BURLINGTON DEVELOPMENT REVIEW BOARD Tuesday January 24, 2017, 5:00 PM BCA City Arts, Lorraine B. Good Room, 135 Church St, Burlington, VT SPECIAL MEETING AGENDA

TO: Development Review Board
FROM: Scott Gustin & Mary O'Neil, Principal Planners
DATE: January 24, 2017
RE: 17-0623CA/MA; 329-375 North Avenue

Known as Cambrian Rise, the application proposes development with mixed commercial and residential uses, related buildings and infrastructure across approximately 21.65 acres (per plan BA1) at 329-375 North Avenue. The total unit count has fluctuated somewhat and is presently at 735 residential units, inclusive of the 65 units already permitted in the former orphanage building.

OVERALL SHADE CALCULATION TOTALS

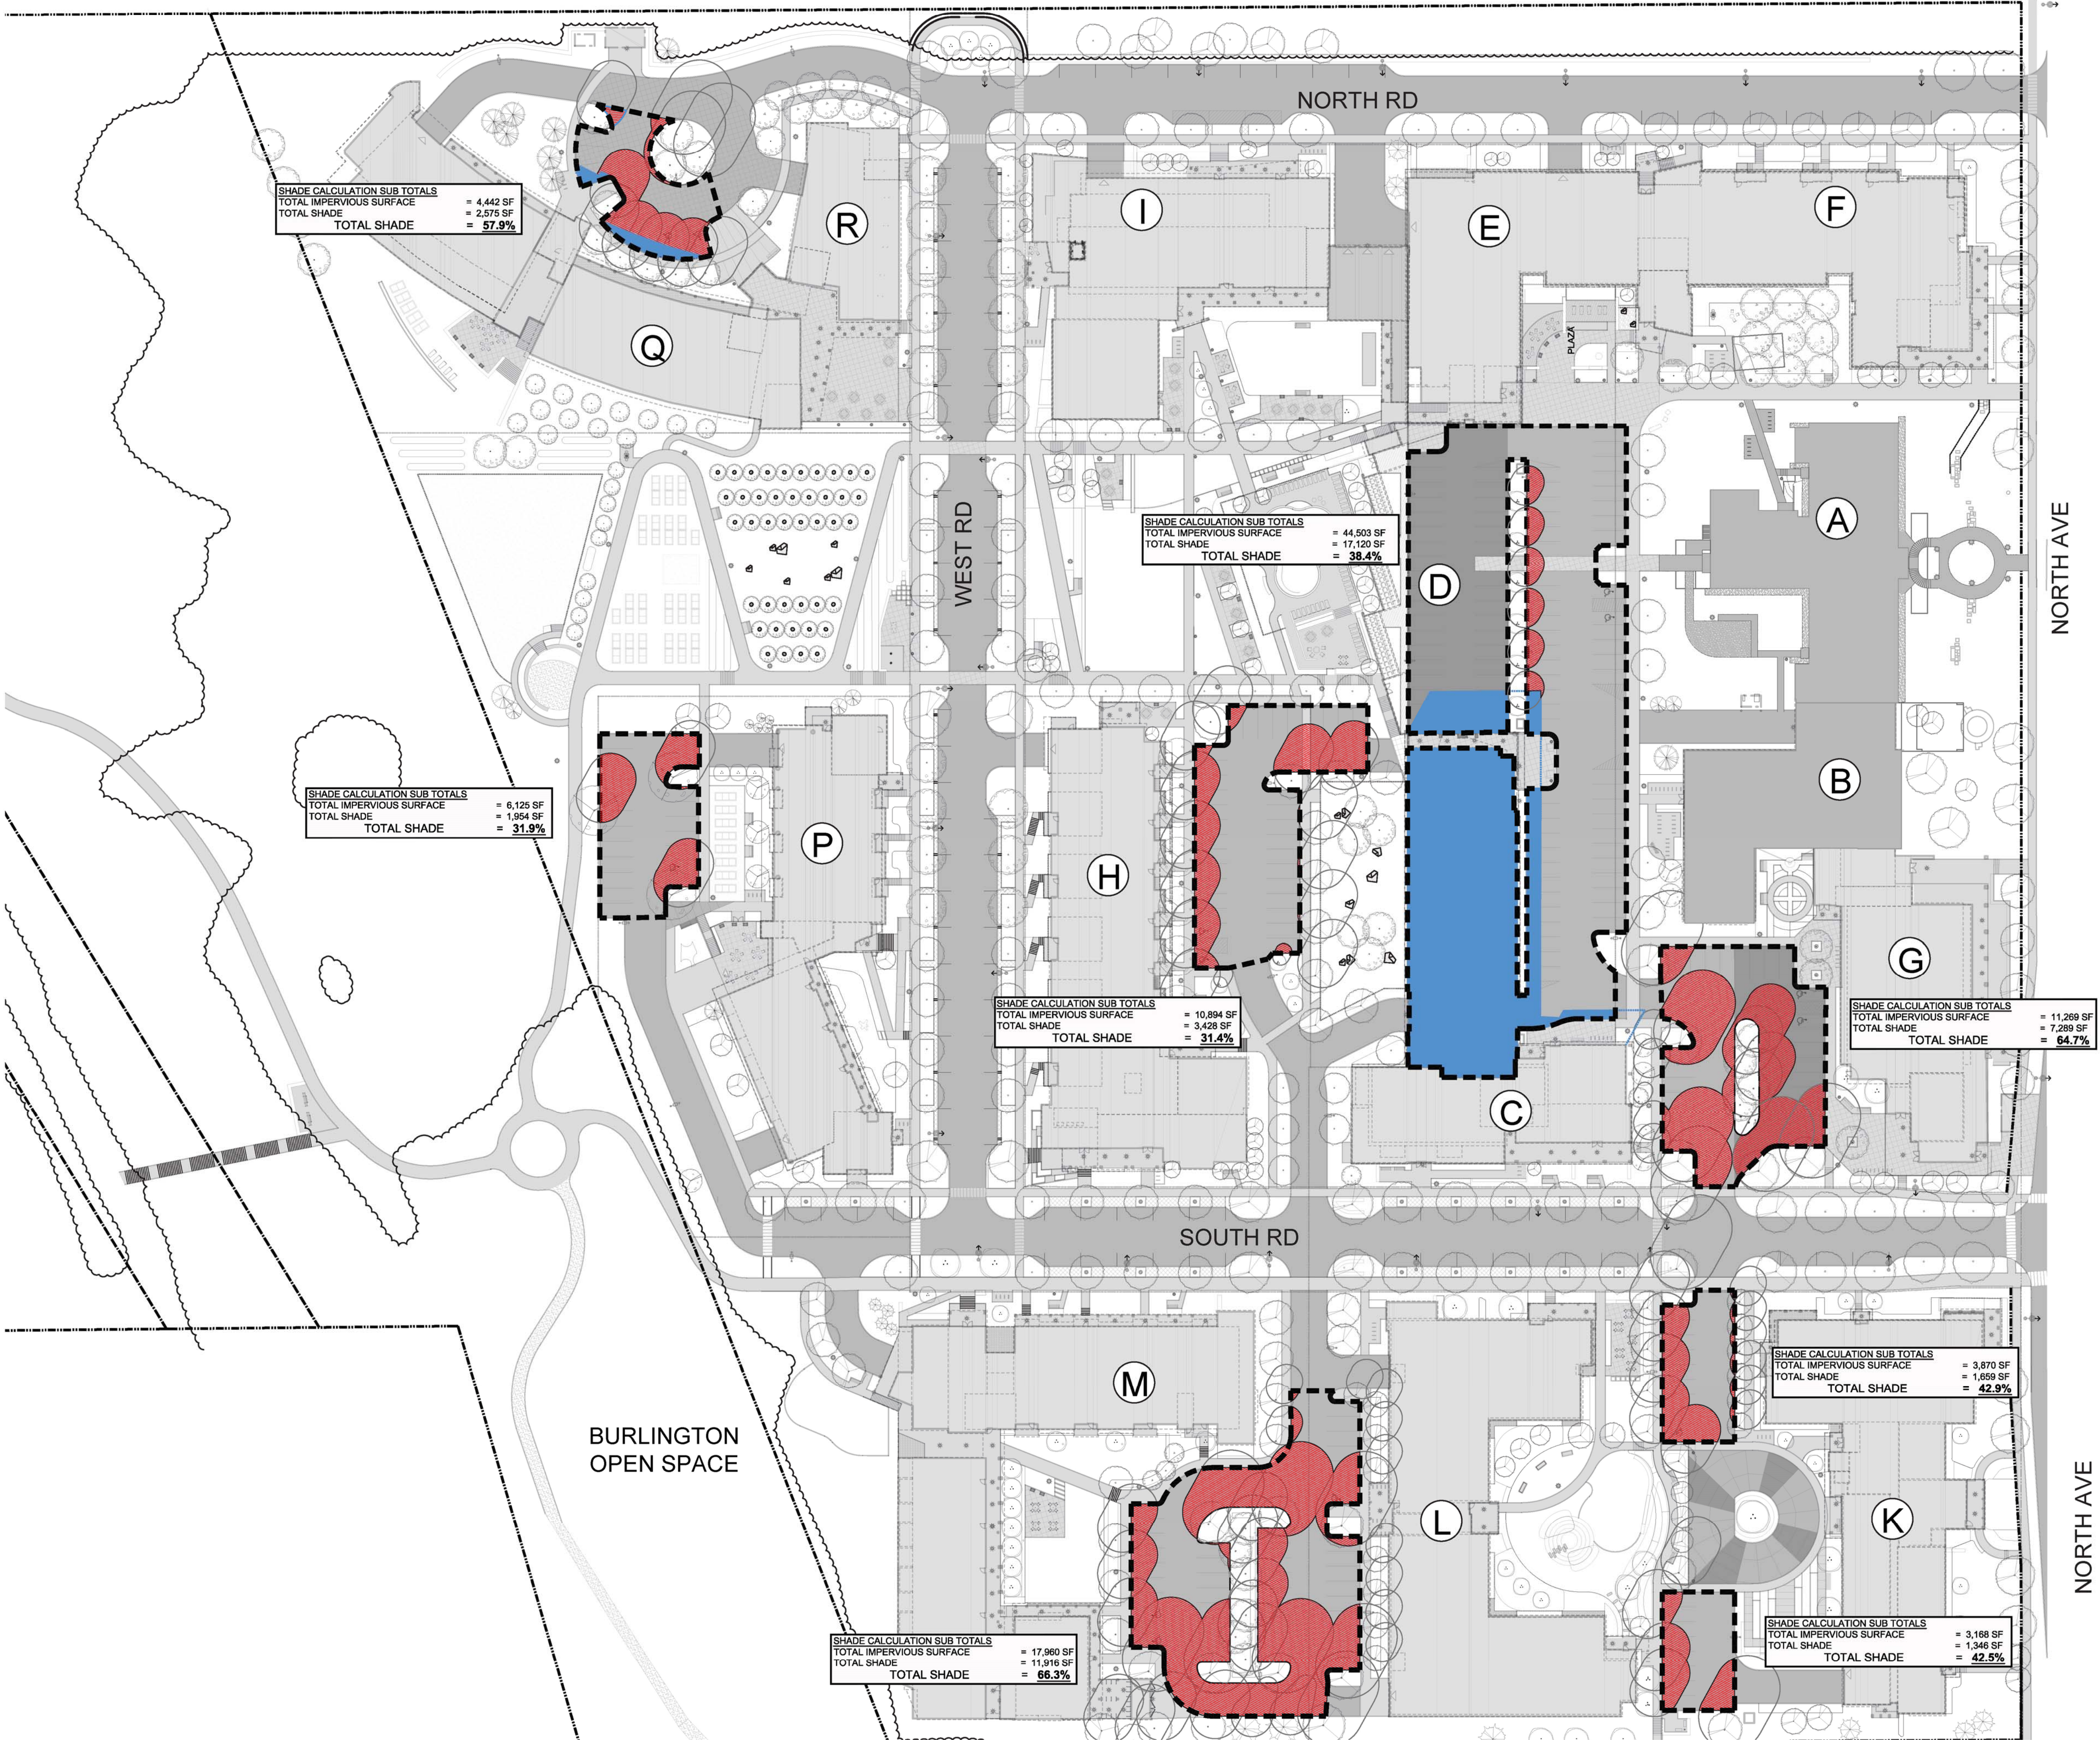
The submission materials include a shading calculation (L-EX1) which now provides a shading calculation on a parking lot by parking lot analysis. The most challenging is “D”, which is a multi story parking facility. Revised plans depict shade trees within the parking deck planter. This effort will generate tree shading in an area wherein none was previously thought possible, where planting trees is not possible. When calculating the entire parking deck that is shaded by the northerly section of Building C and these new shade trees, the total parking lot shading is greater than the 30% prescriptive standard. The standard specifically states: *Surface parking and maneuvering areas should be shaded in an effort to reduce their effect on the local microclimate, air quality, and stormwater runoff with an objective of shading at least 30% of the parking lot.* With this consideration, and anticipating some natural shading from adjacent buildings the required objective will be met.
